**From:** John Hodnett [REDACTED]  
**Sent:** Thursday 29 December 2022 21:35  
**To:** Development Plan  
**Subject:** Proposed Amendments to the Draft Clare Draft Development Plan 2023-2029  
**Attachments:** Map of drumbiggle area.png; Veon Bats Report.pdf

# Review of Bat Survey conducted at a proposed development site at Drumbiggle, Co. Clare.

**Compiled Daniel Connell, Senior  
Ecologist, Veon Ecology.**

**Completion date: 5<sup>th</sup> April 2022**

Figure 5-3 Bat Species Composition - Dusk activity survey.

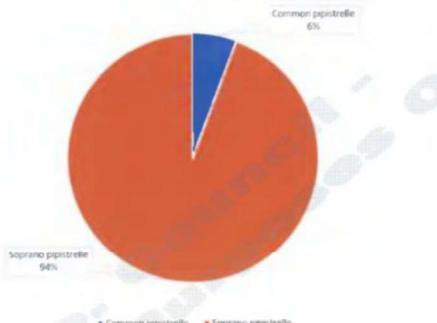
The results in the Bat Survey mentions Transect routes were used in northern end – but as noted already in this review, these transects were not mapped – neither start or end points nor distances covered, only that they travelled from east to west.

It also states that habitats within the proposed site were assessed for Foraging and Commuting potential – however, there are no specific details in the published Bat Survey report regarding flight paths, no evidence of species-specific feeding buzzes either having been identified or recorded, no commuting routes, and no mapping of the same.

This information is critical to know what habitat features must be retained or where mitigation measures must be located. The loss of commuting routes is a major factor in the isolation of horseshoe colonies throughout their Irish distribution.

Figure 5.5 Bat Passes Per Night

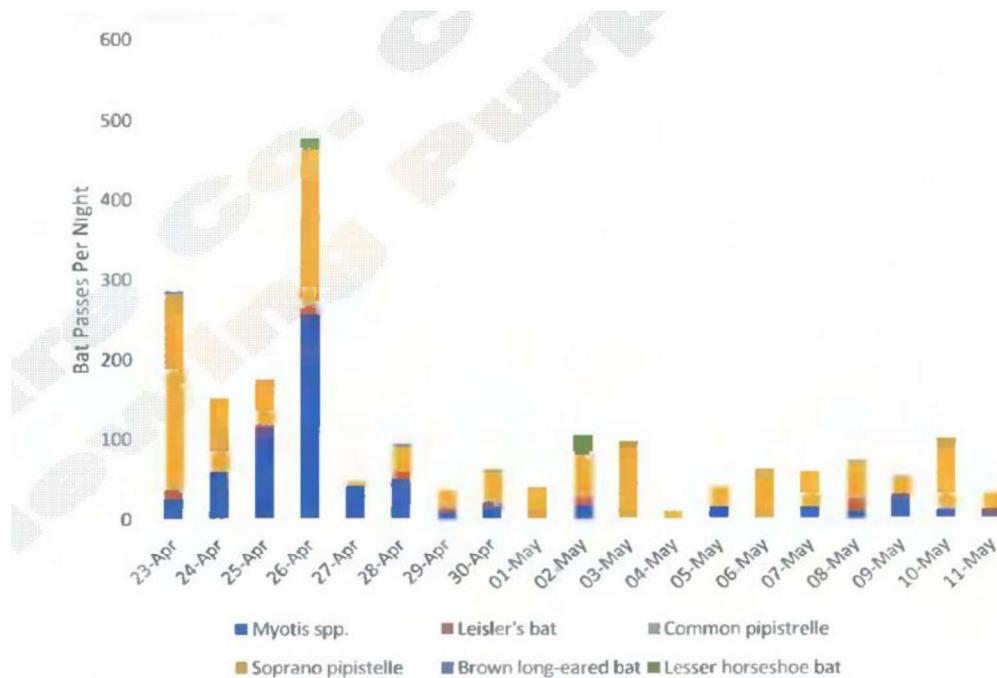
However, this data must exist for the ecologists to make this reasoning. MKO should clarify what this data is and why it was not included in the published results.

In the absence of this data, it should not be taken at face-value that this is the actual cause for the decline in activity. The reasons could be numerous, from poorly positioned locations of the passive detectors (this point is discussed further below) to a potential cases of power loss or technical faults during the 19 days survey time.

There is no evidence in the reports to confirm whether the passive devices were checked for continued operation during the survey period to ensure consistency of recordings. It could be that the detectors were routinely checked, but this should be clarified by MKO to ensure confidence in the reader that none of the data captures (or rather more so the interpretation of that data) is compromised in any way.
